PREDETERMINATION SETTLEMENT AGREEMENT

CP# 08-16-69447
HUD# 07-16-4728-8

Subject Property

Light Switches, Electrical Outlets, Thermostats, and Other Environmental Controls in Accessible Locations – Thermostats

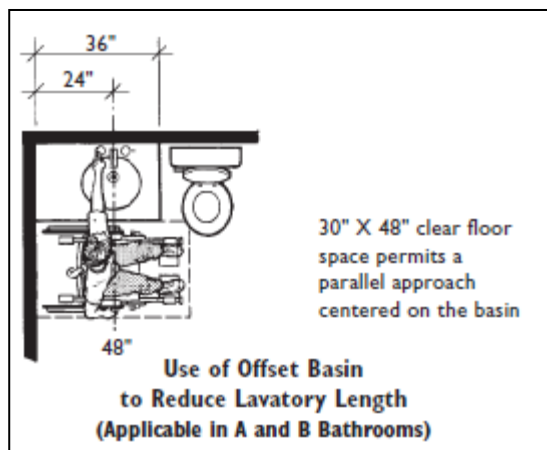
- (a) The parties agree the height of the thermostat controls in all inspected units, except for Unit 9202 [Napa] exceed the maximum height of 48 inches, as allowed by the Manual.
- (b) Respondents agree they will lower the thermostat controls in all inspected ground-floor units, such that the display screen and all operating buttons do not exceed maximum height of 48 inches, as required by the Manual.
- (c) Respondents agree to measure the height of the thermostats display screen and operating buttons in all other ground-floor units not inspected by ICRC Investigators. If the height of the thermostats is greater than the 48-inch maximum height allowed by Manual, Respondents agree to retrofit the thermostats in the same manner as described in “(b)” paragraph above to bring it into compliance with the ICRA and FHA.
